CITY OF TAMPA

CONTRACT ADMINISTRATION DEPARTMENT

ADDENDUM NO. 1

Contract 14-C-00056; Harbour Island Roadway Surface Replacement

**REPLACEMENT
 PARTIAL PLANS
 SECTIONS C & D**

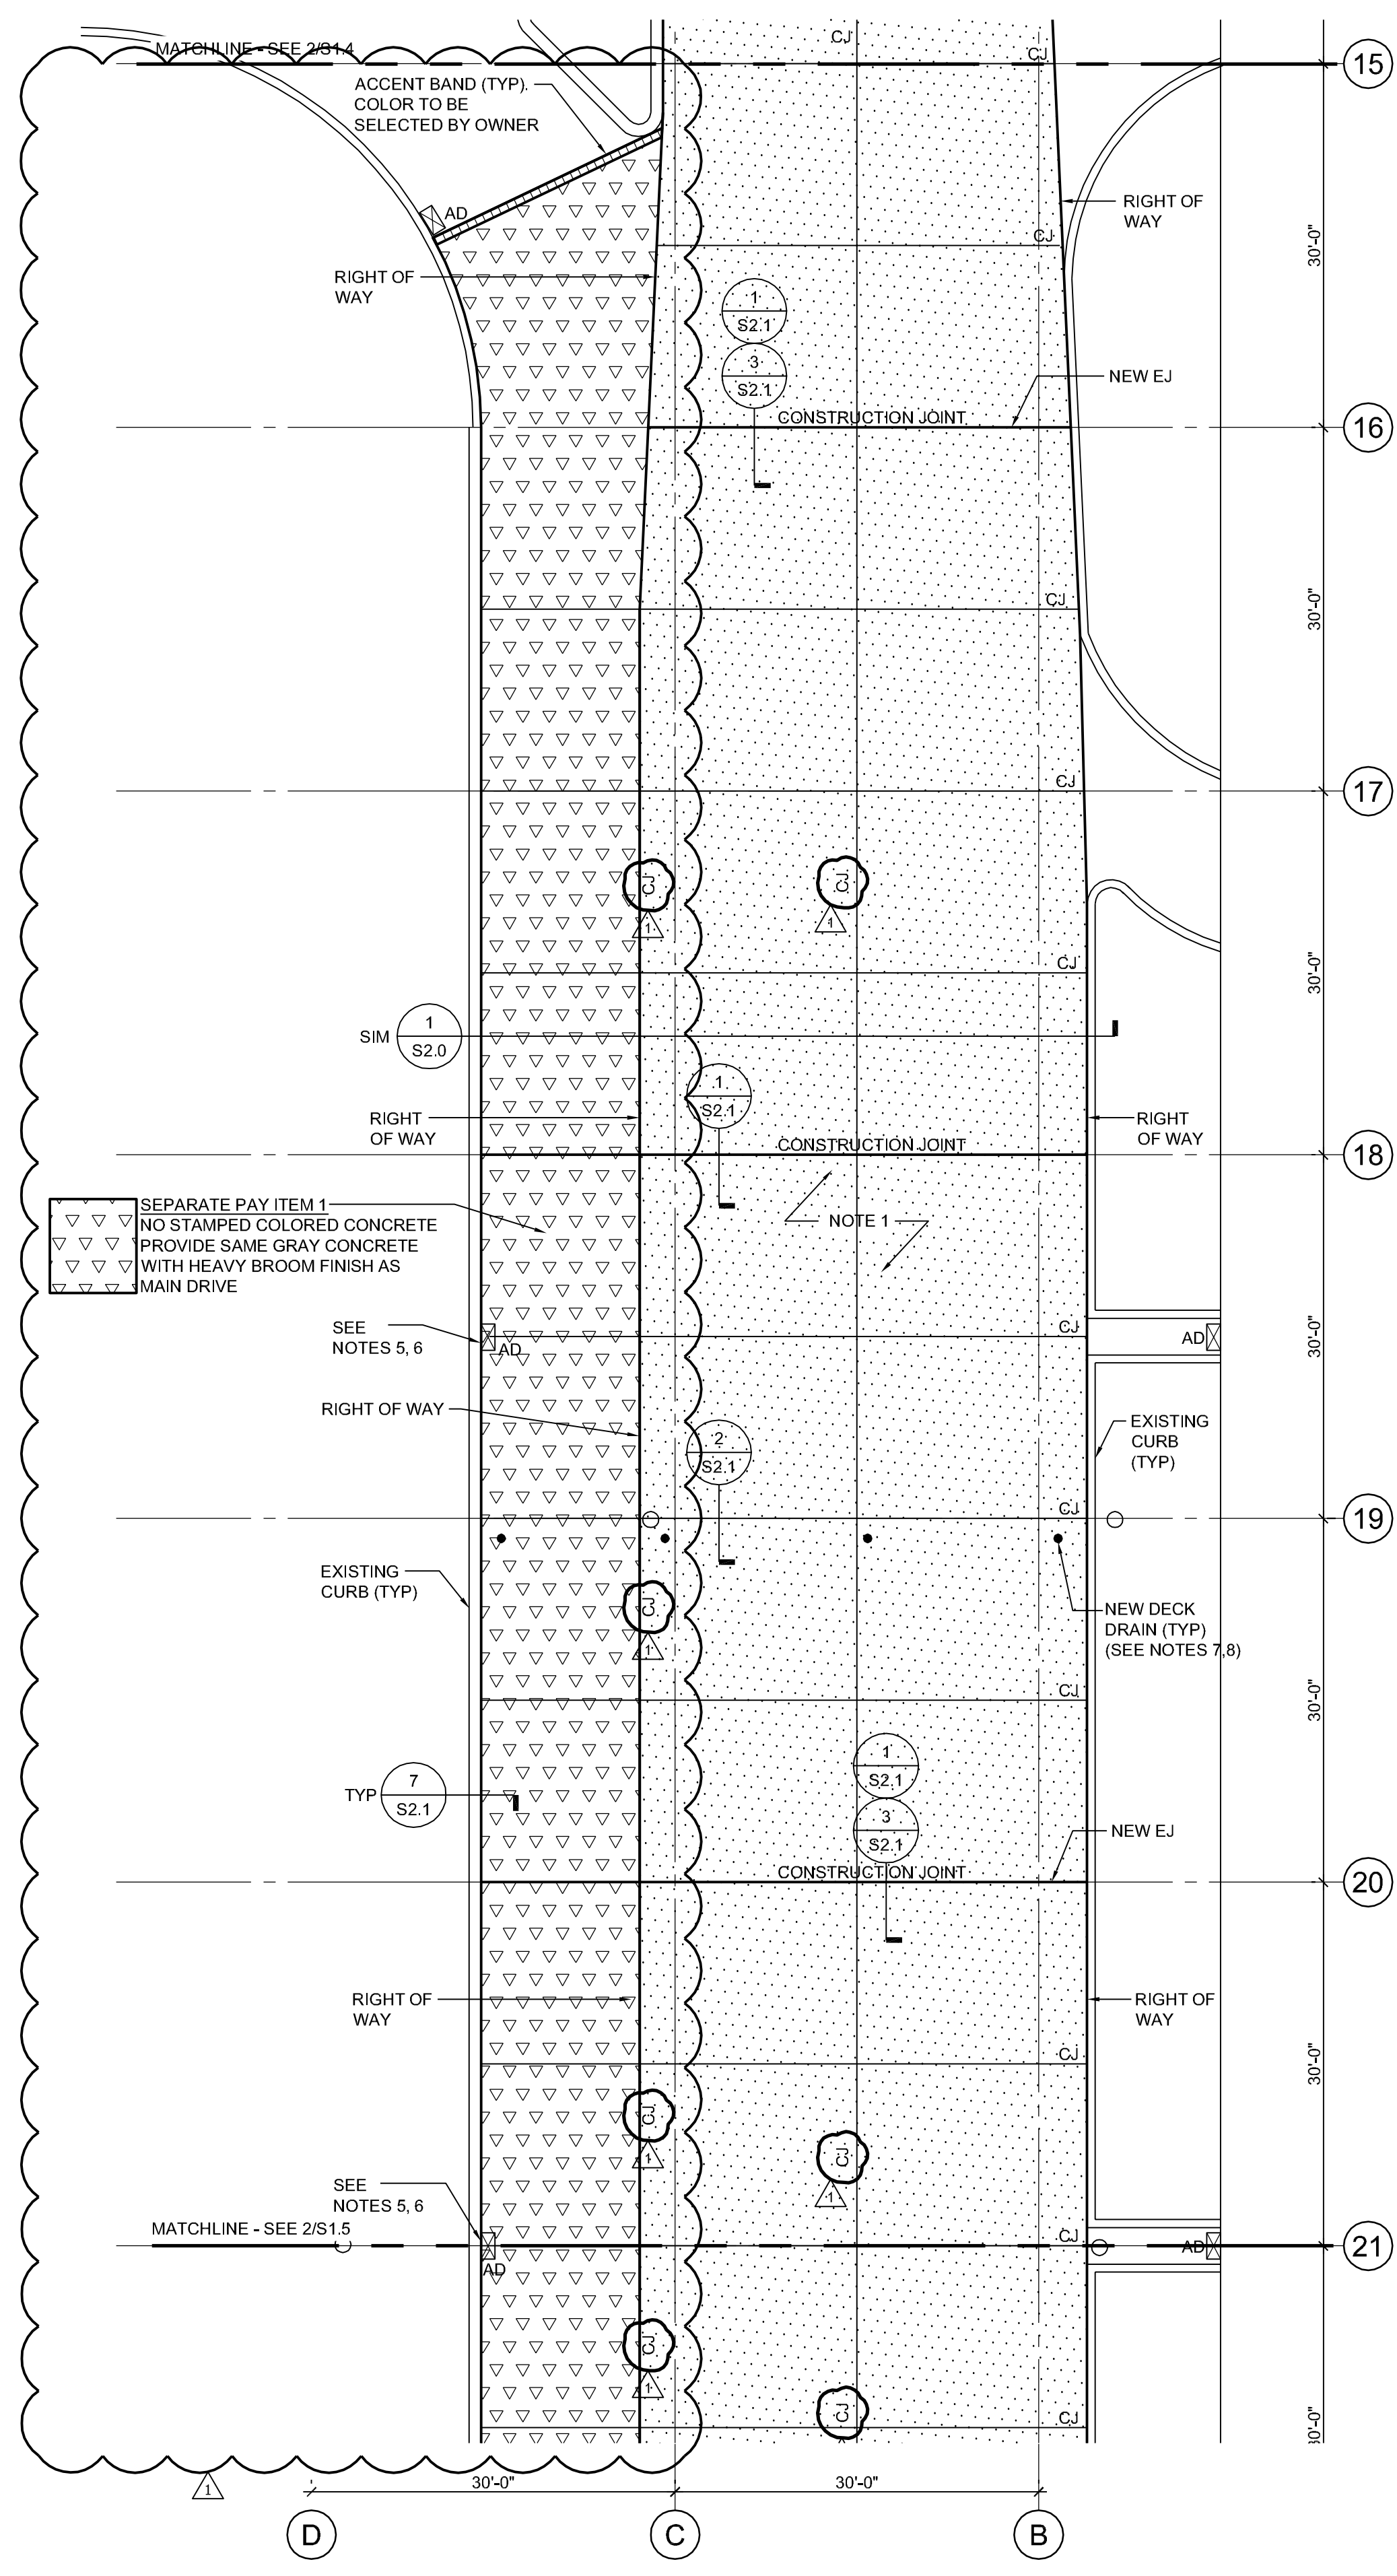
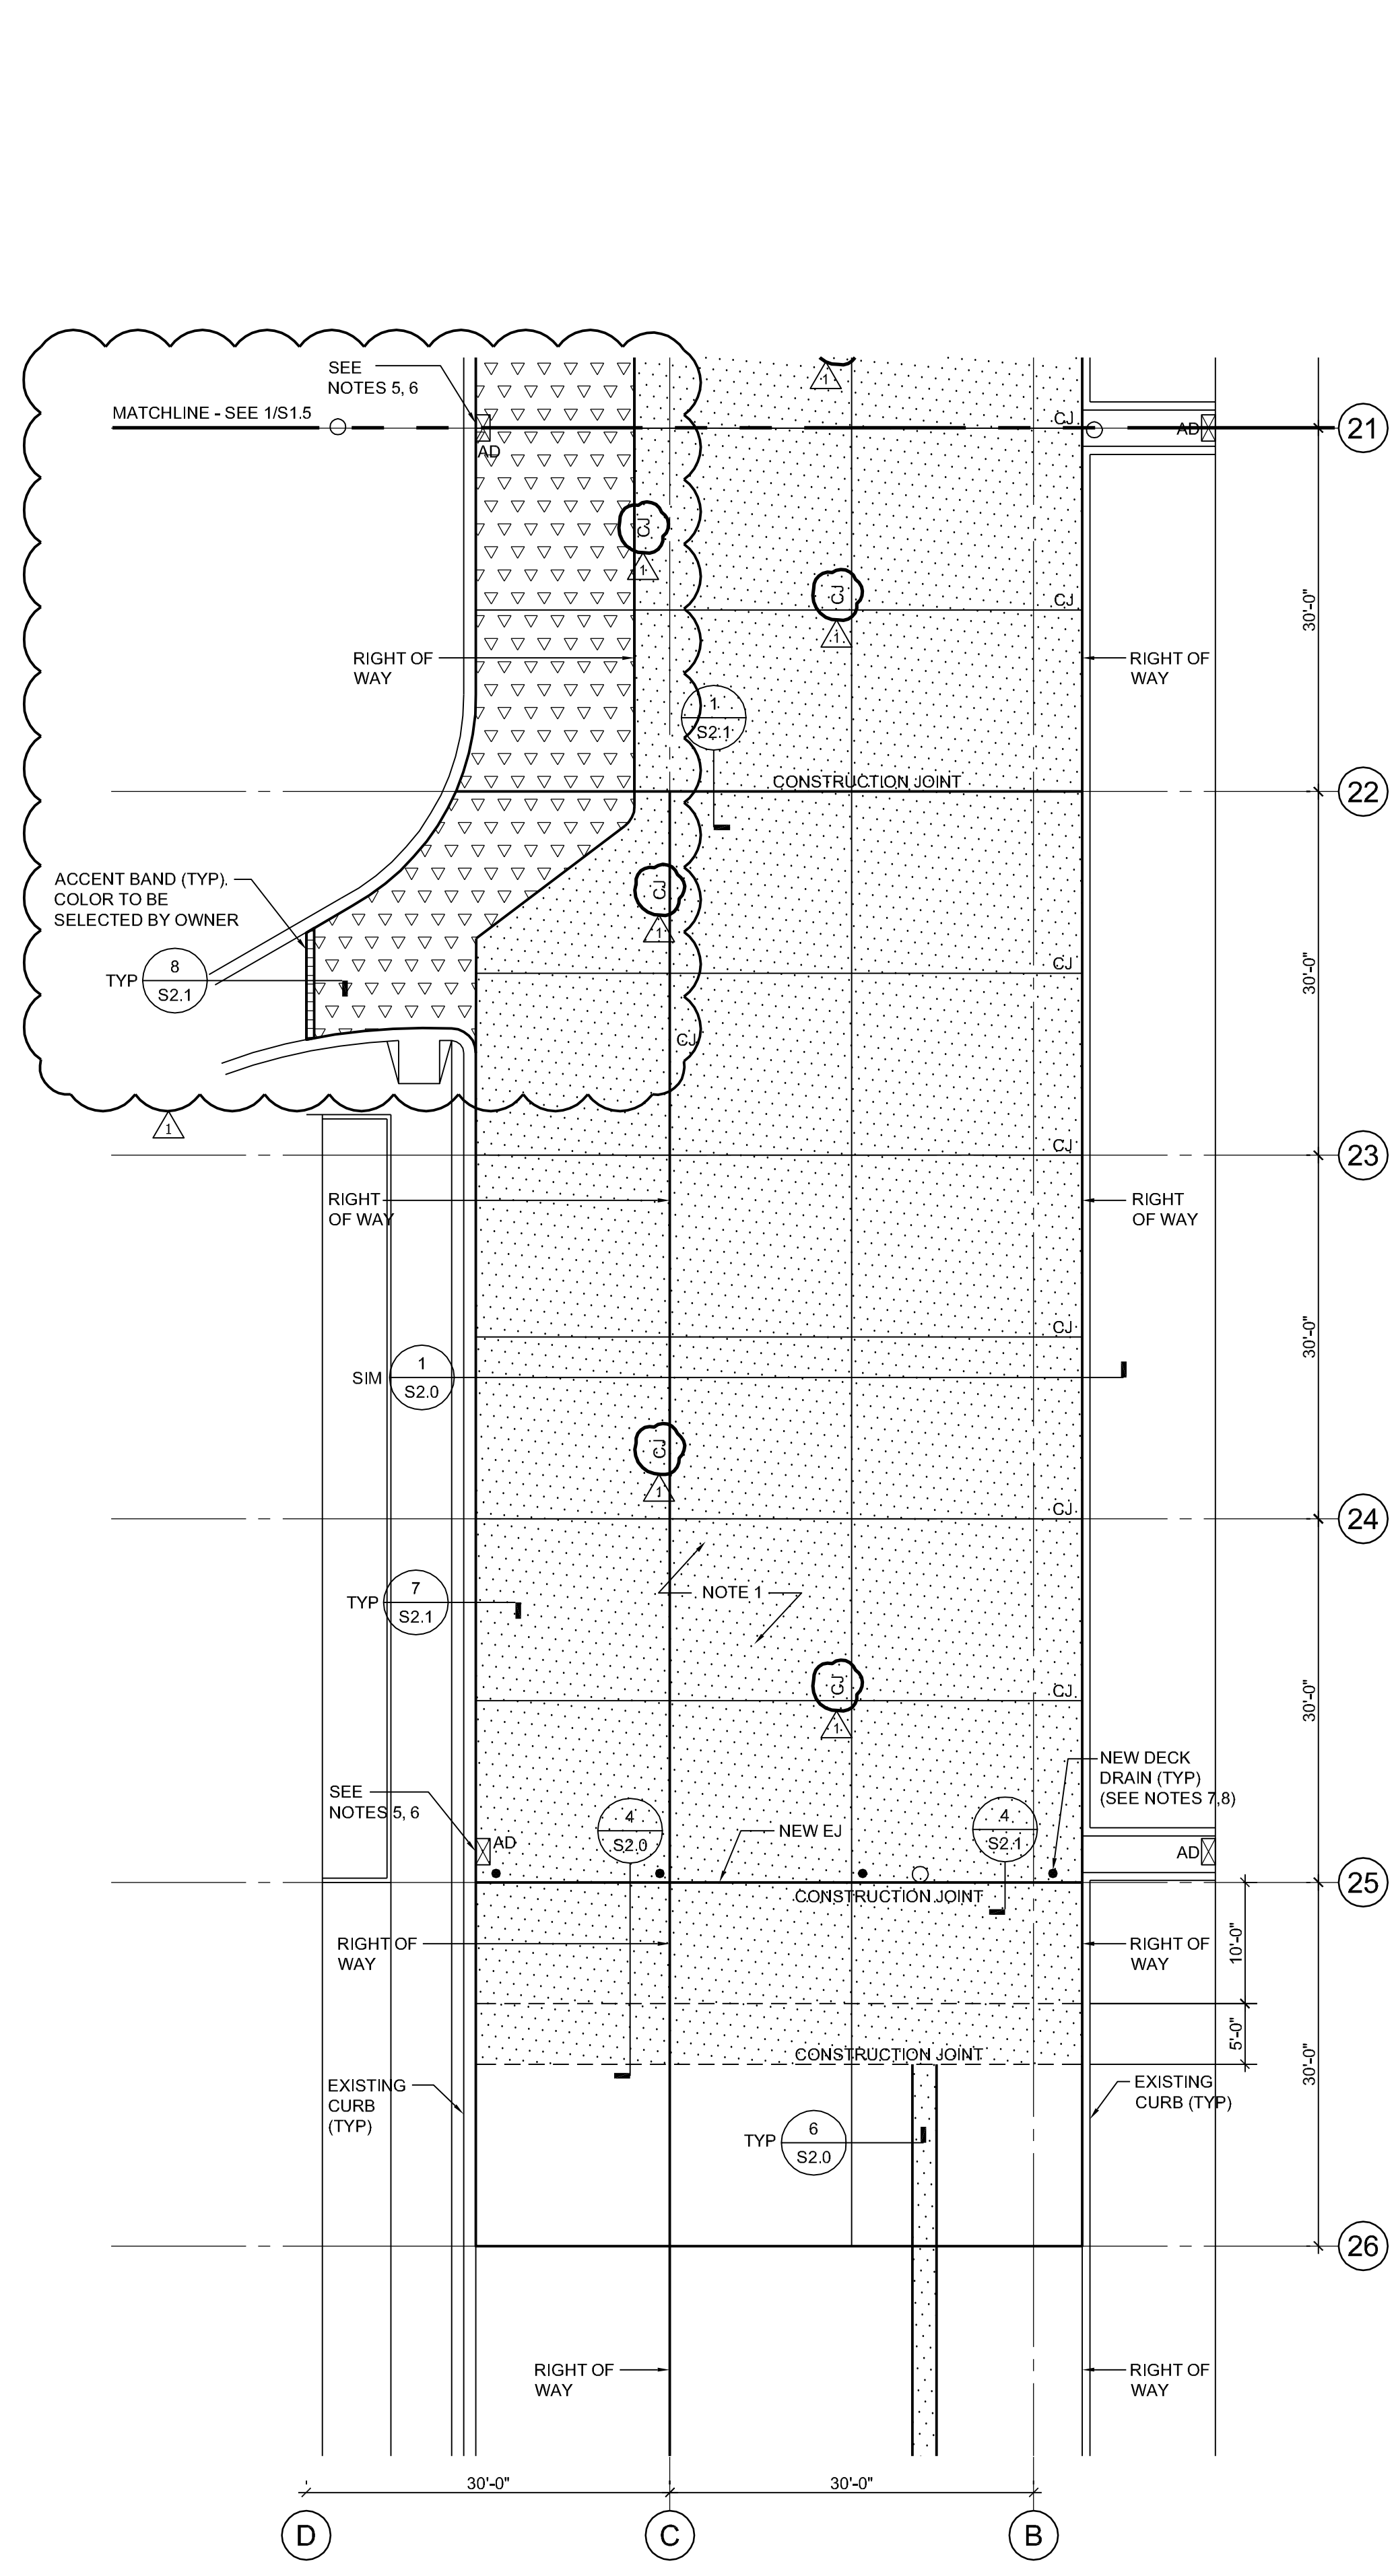
1. AESTHETIC SURFACE DESIGN REQUIREMENTS:
 ACCENT BAND TO BE PROVIDED BETWEEN EXISTING COLORED STAMPED CONCRETE AND ADJACENT PROPOSED UNCOLORED CONCRETE.
 EXISTING STORM DRAINS ARE NOT TO BE RE-CONSTRUCTED.
 3. EXISTING PAVERS IN THE MEDIAN ARE NOT TO BE REPLACED. THESE AREAS WILL RECEIVE SPECIFIED CONCRETE TOPPING SLAB ONLY.
 4. BROOM FINISH ALL CONCRETE TOPPING SLAB FINISHES. REFER TO SPECIFICATIONS.
 5. CONTRACTOR SHALL PREPARE 2 FT BY 2 FT MOCKUP SAMPLE FOR EACH TYPE OF STAMPED AND/OR COLORED CONCRETE FOR CITY, HICSA AND ENGINEER APPROVAL PRIOR TO COMMENCING WITH PLACEMENT OF NEW TOPPING SLAB.
